In the Drawings

REMARKS

Amendments to the Drawings

FIG.8

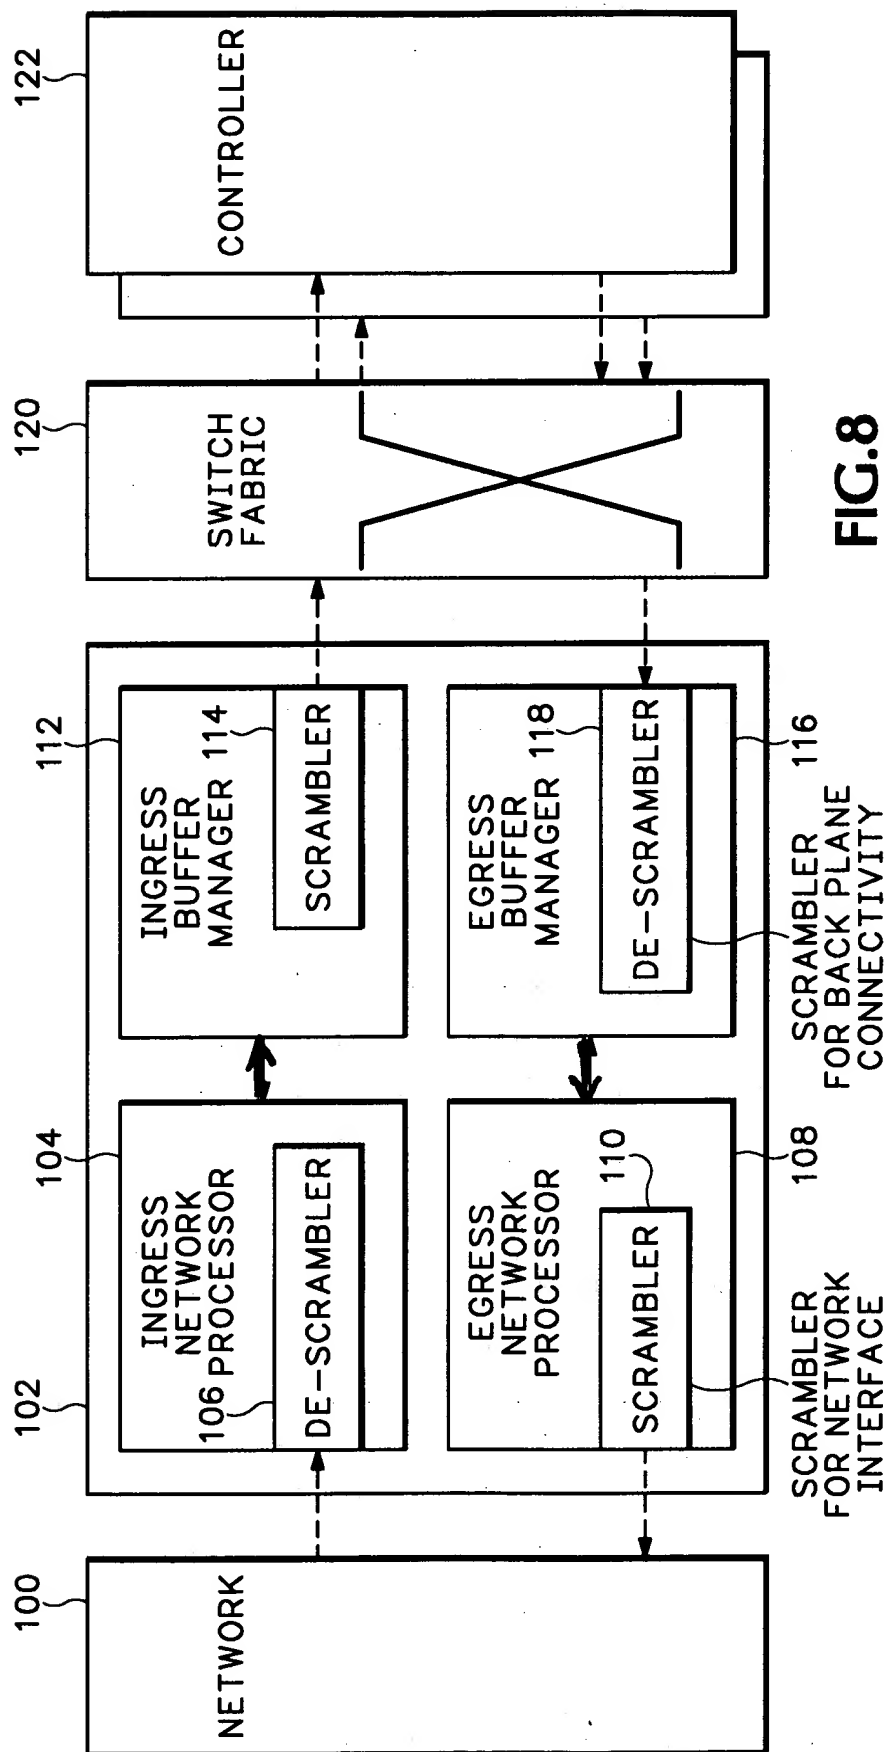
The Office Action indicates several potential informalities in the drawings. First, the Office Action indicates that Figure 4 contains a misspelled label "Scambler Polynomial." Second, the Office Action indicates that Figure 8 contains incorrect flow directions between elements 104 and 112 and between elements 116 and 108. Applicants were able to locate the version of the drawings to which the Examiner was referring, and apologize for their confusion. Figures 4 and 8 have now been updated to address the informalities identified by the Examiner.

Replacement sheets for figures 4 and 8 are submitted herewith, along with marked up copies for the Examiner's approval, showing the changes made to figures 4 and 8.
